Helio board :Power supply to HSMC

> Now(V1.1 and V1.2)

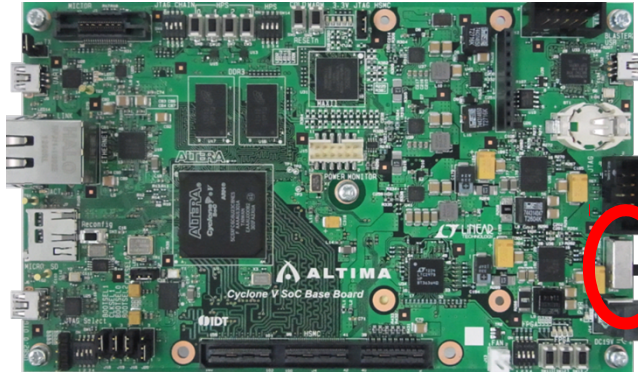
There is some possibility to cause device destruction on the Helio / daughter cards in the following situation.

- Customer connects AC adaptor Helio and electric point, but power switch position is “OFF”
- When customer connects daughter card to Helio’s HSMC, daughter card doesn’t connect securely
- In this situation, there is possibility that electric current flows between Helio and daughter card, and device on the board may become destroyed.

Remove this switch
This means that Helio is powered on when customer will connect power cable to Helio.
